**Florida
Power**
CORPORATION

Subject: Crystal River Unit 3
Docket No. 50-302
Operating License No. DPR-72
Technical Specification Change Request No. 39

Revisions to Technical Specification Change Request No. 39 for (1) 2452 MWt versus 2544 MWt; (2) deletion of the Reactor Coolant Power Pump Monitors; and (3) Item 5 of IE Bulletin 79-05B.

FIGURE 2.1-1
REACTOR CORE SAFETY LIMIT

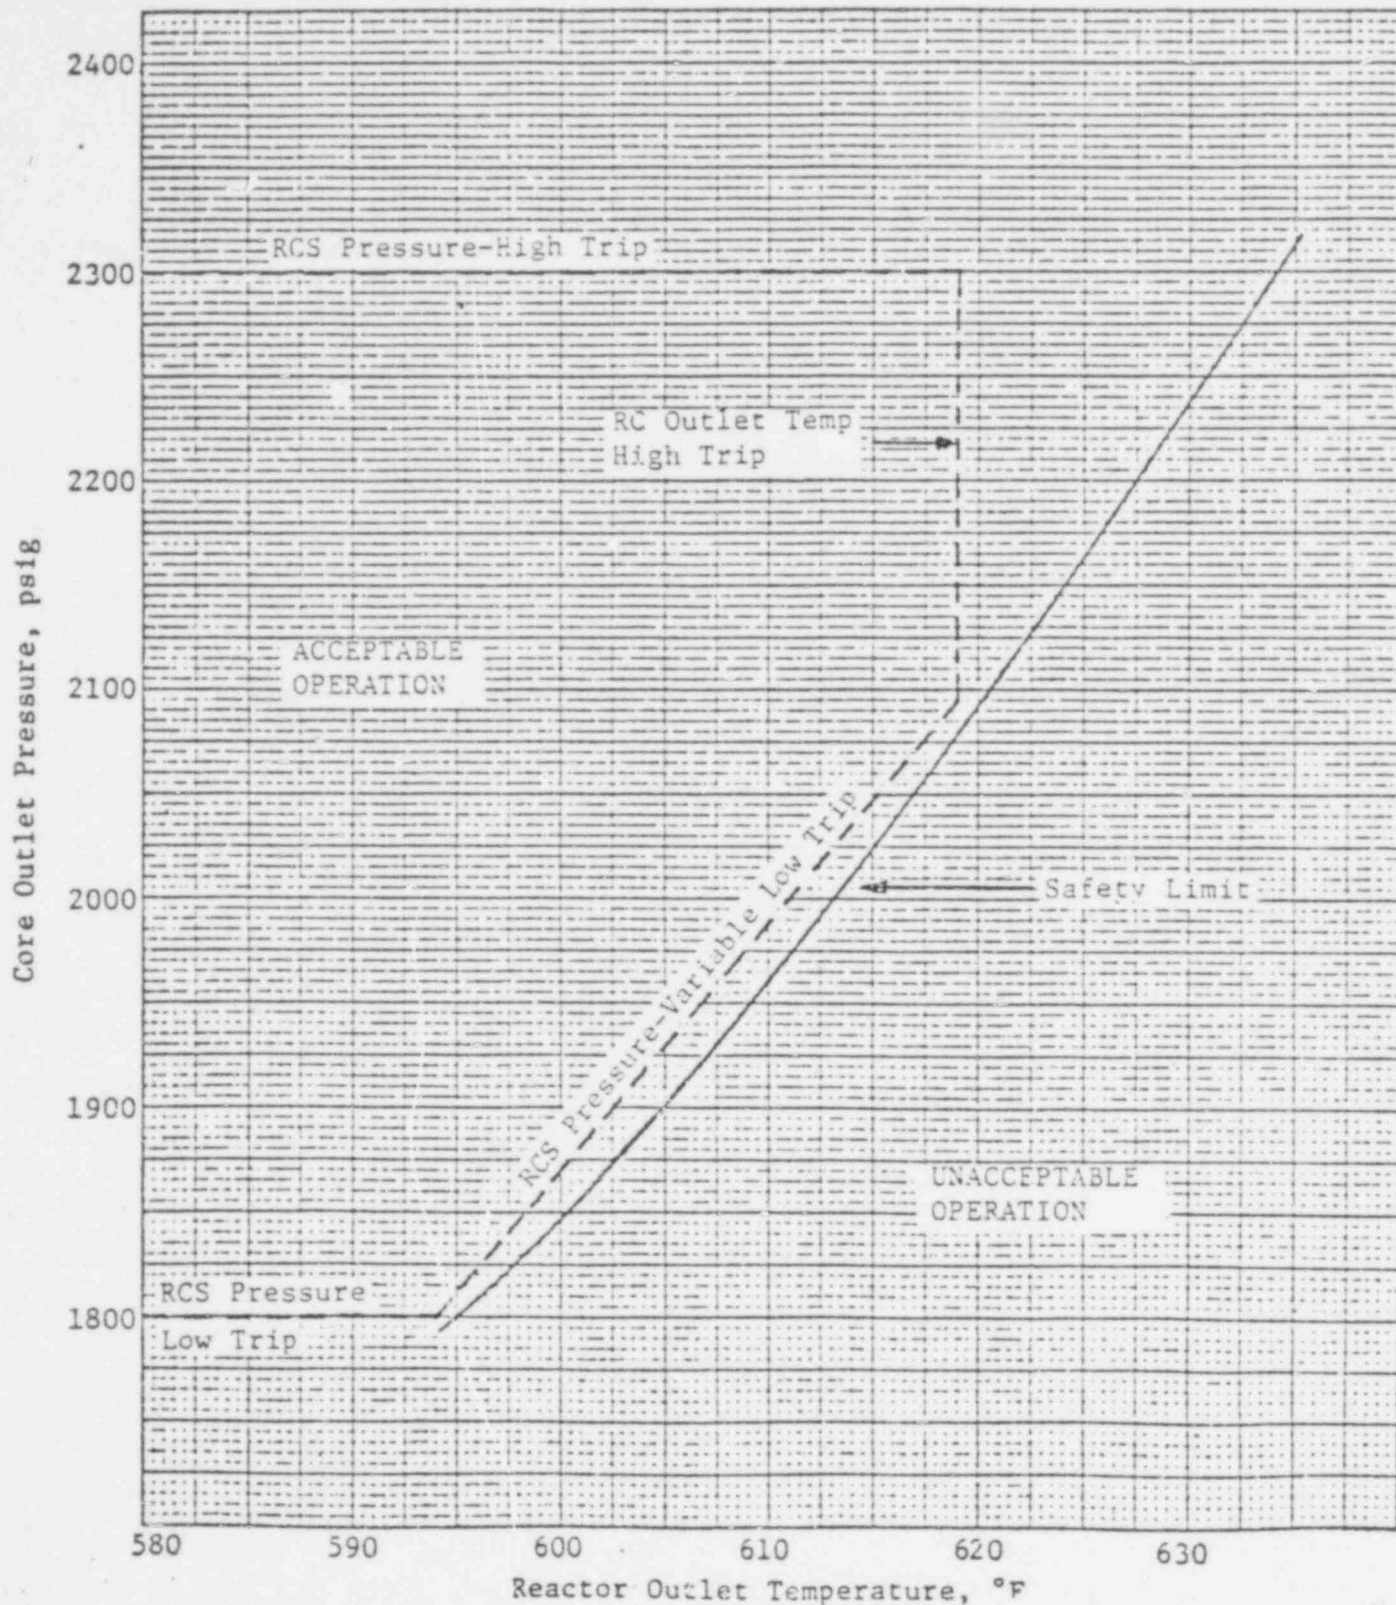
- Page 2-2: In Figure 2.1-1, the RCS Pressure-High Trip should be redrawn as 2300 psig instead of 2355 psig.
- Page 2-3: In Figure 2.1-2, the limit line for acceptable 3 & 4 pump operation should be lowered by 2.0% of RATED THERMAL POWER.

BASES FIGURE 2.1

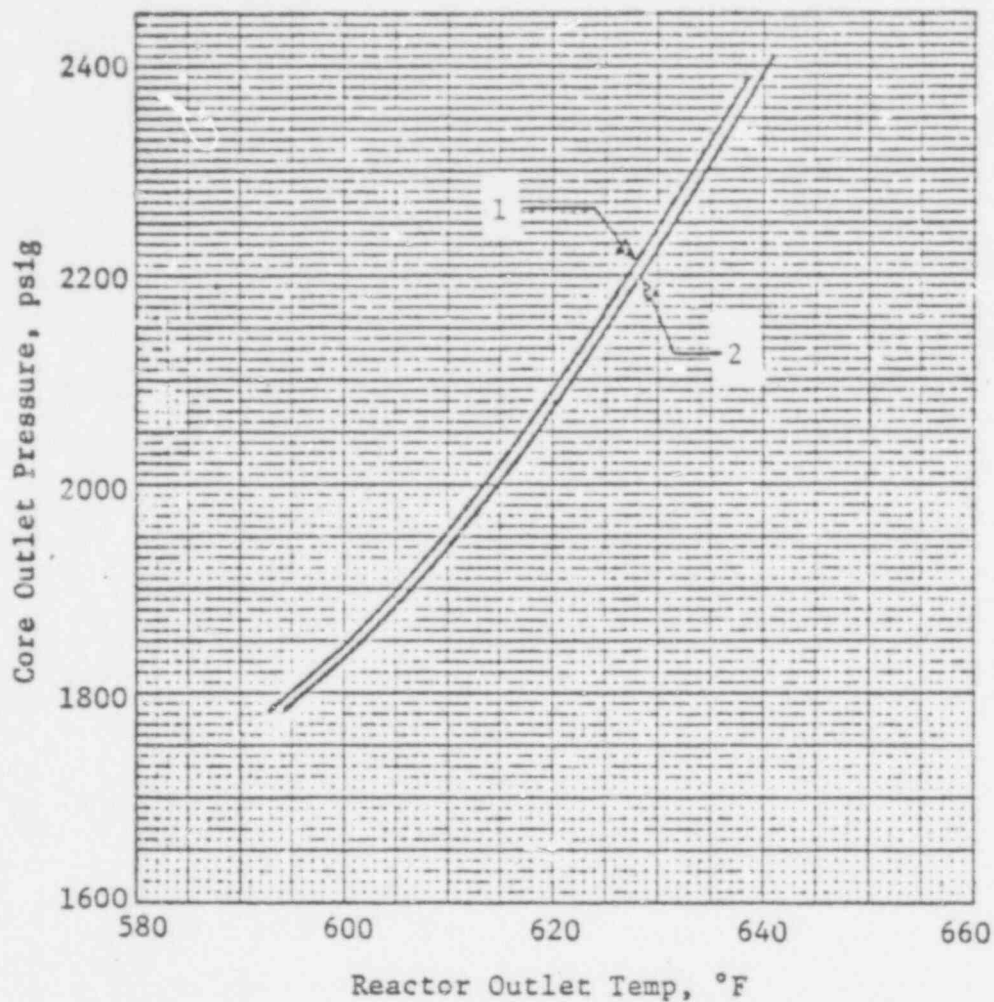
- Page B2-8: For Curves 1 and 2, change the Power (% RTP) to 117.3% and 90.5%, respectively, instead of 113.1% and 87.2%, respectively.

FIGURE 3.1-1

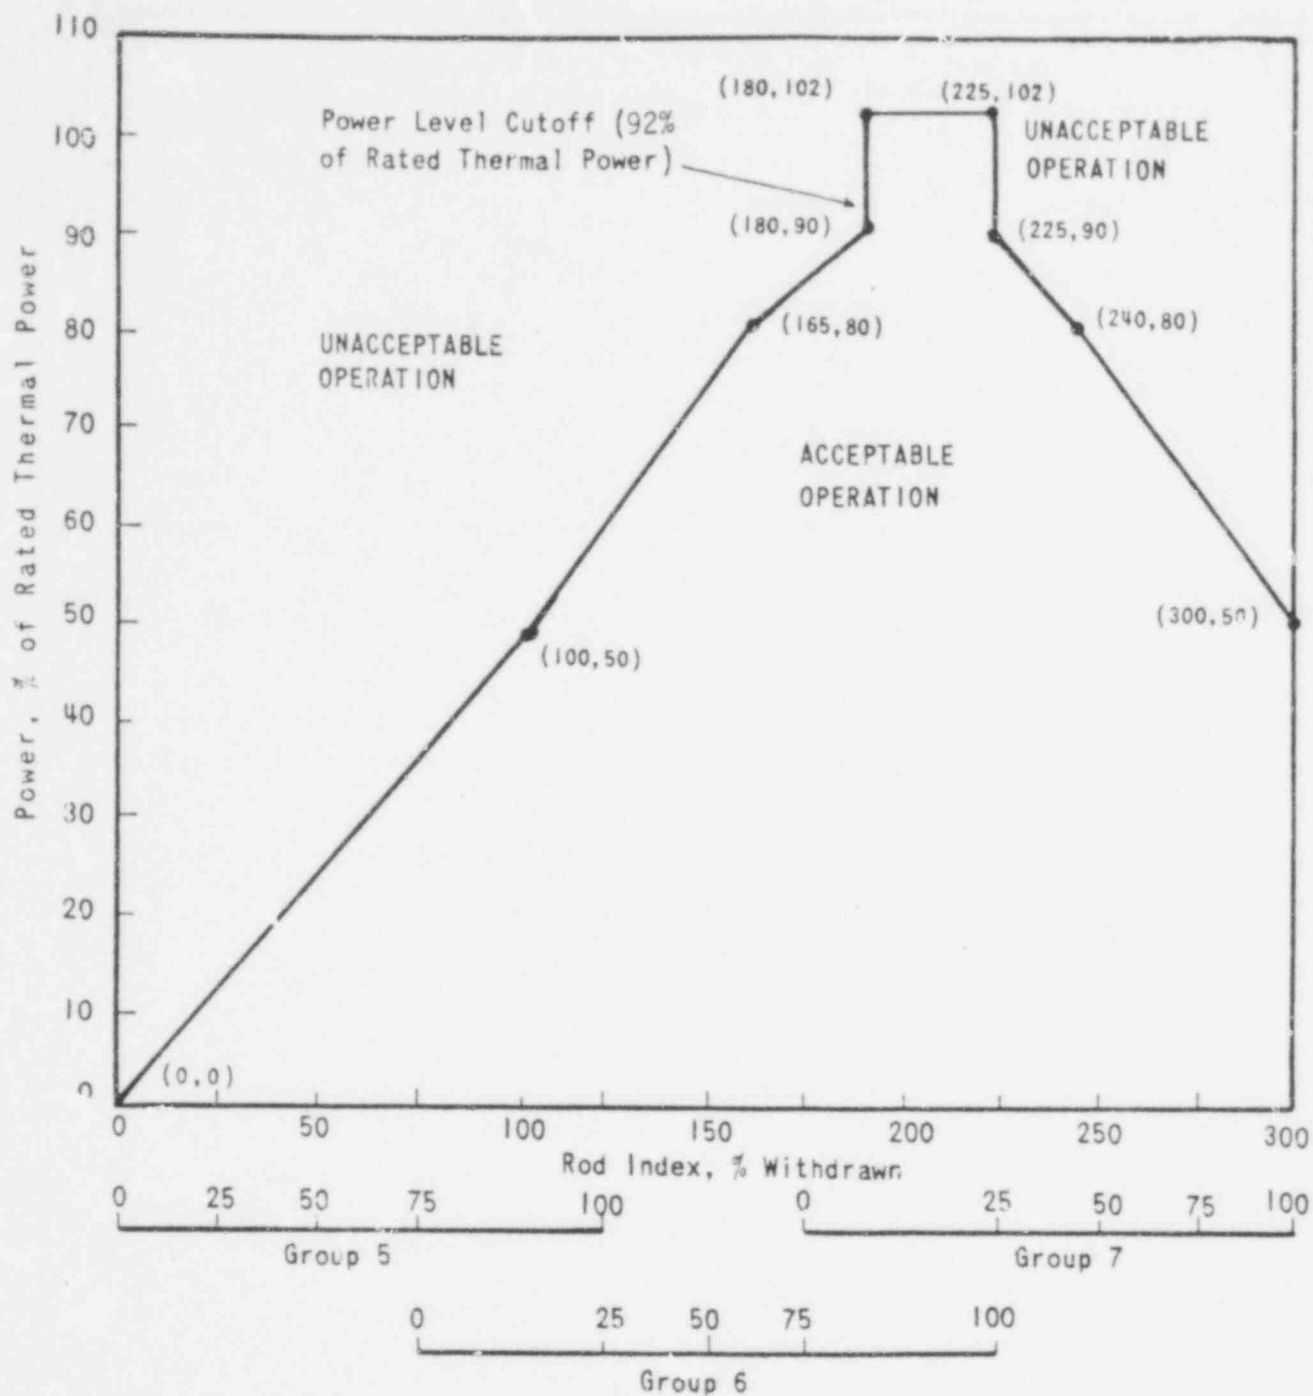
- Page 3/4 1-27: In Figure 3.1-1, change the Power Level Cutoff to 92% of Rated Thermal Power instead of 90%.
- Change the length of mid-Cycle 2 to 233 ± 10 EFPD instead of 225 ± 10 EFPD.

FIGURE 3.1-2

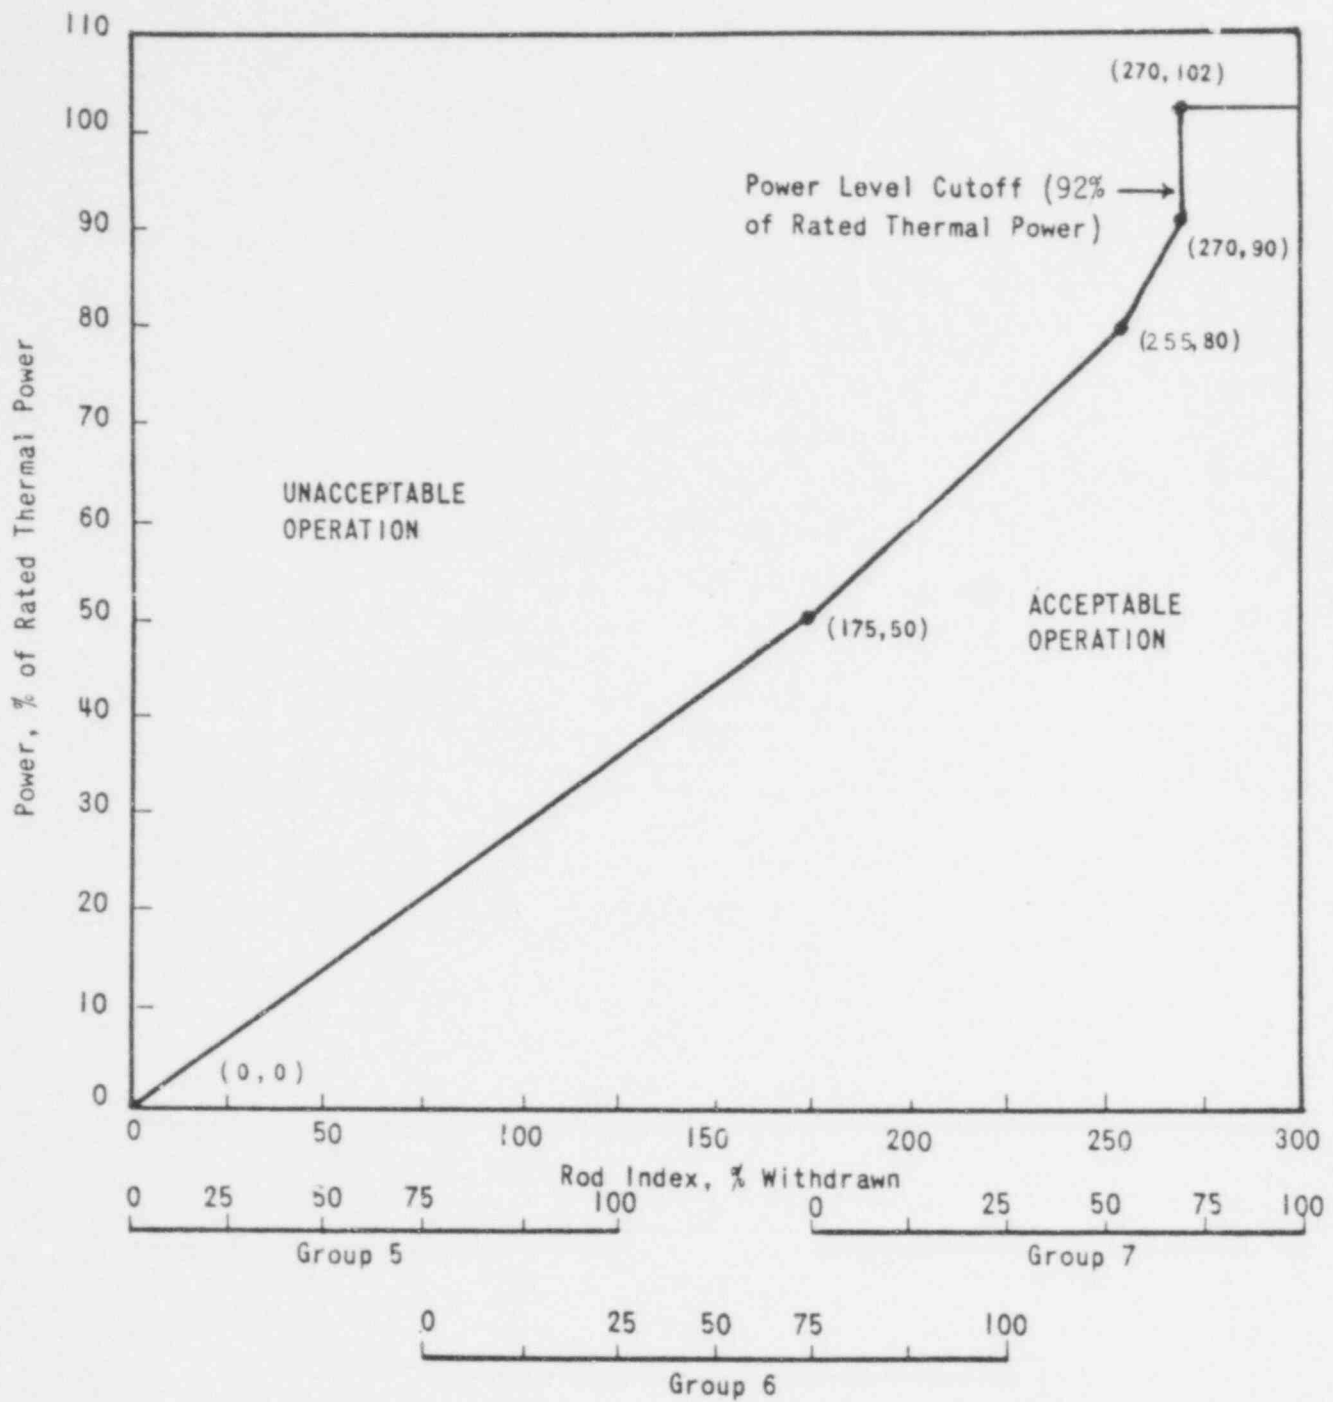
- Page 3/4 1-28: In Figure 3.1-2, change the Power Level Cutoff to 92% of Rated Thermal Power instead of 90%.
- Change the length of mid-Cycle 2 to 233 ± 10 EFPD instead of 225 ± 10 EFPD.

FIGURE 3.2-2

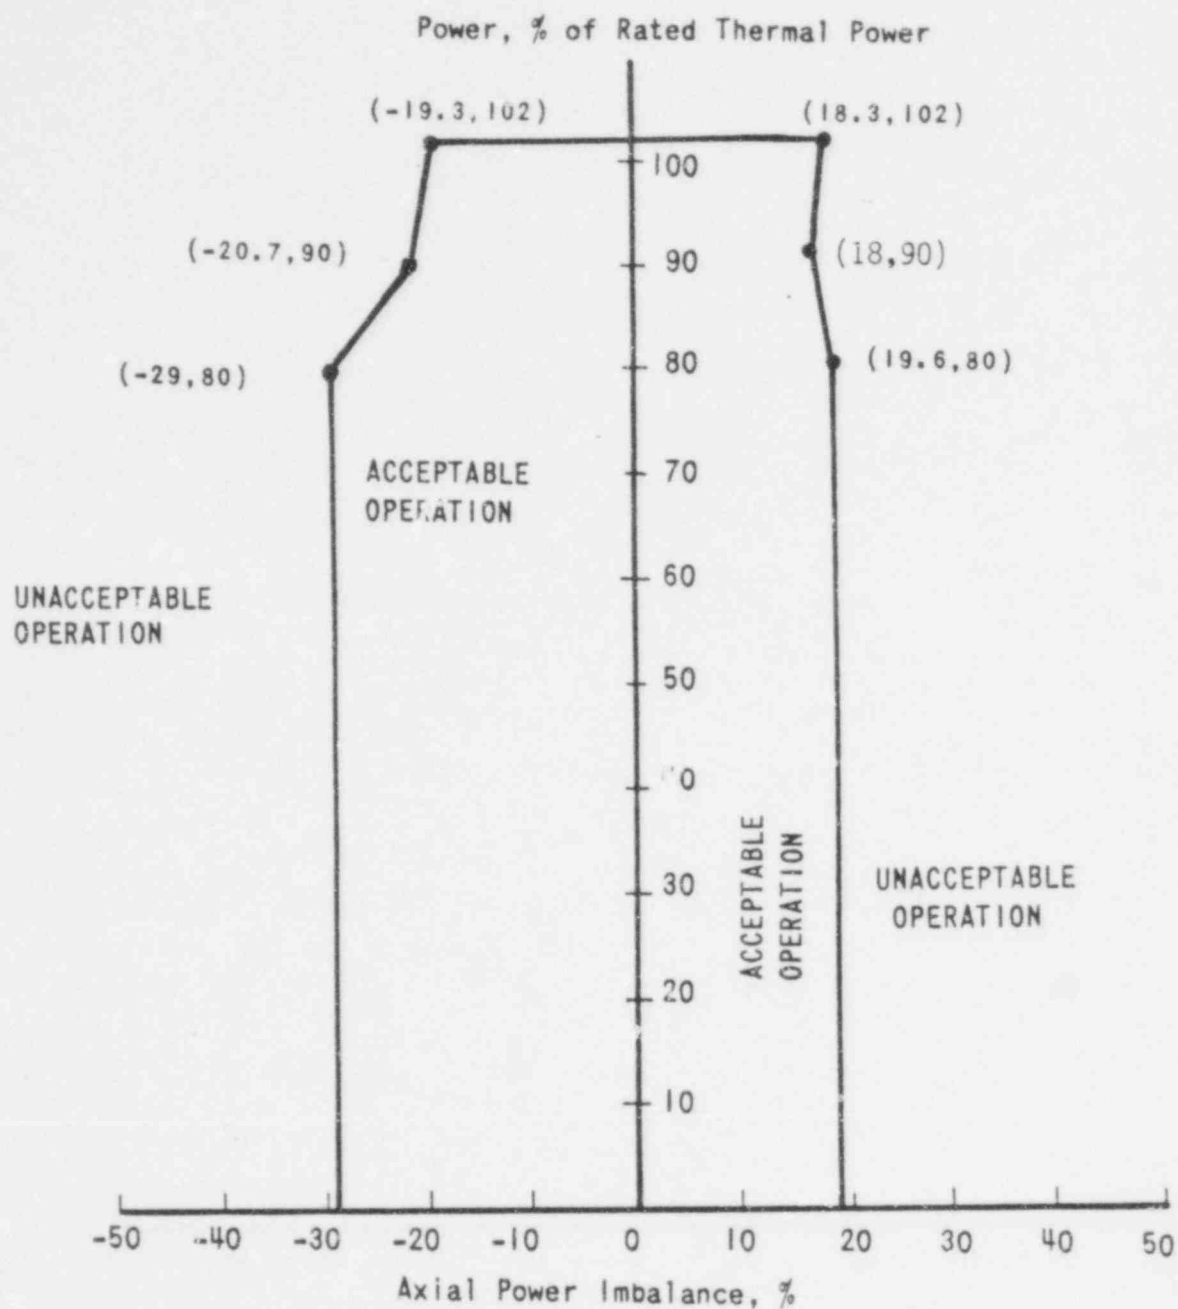
- Page 3/4 2-2: Change the length of mid-Cycle 2 to 233 ± 10 EFPD instead of 225 ± 10 EFPD.
- Page 3/4 2-3: In Figure 3.2-2 the point defined as (18, 92) should be changed to (18, 90).
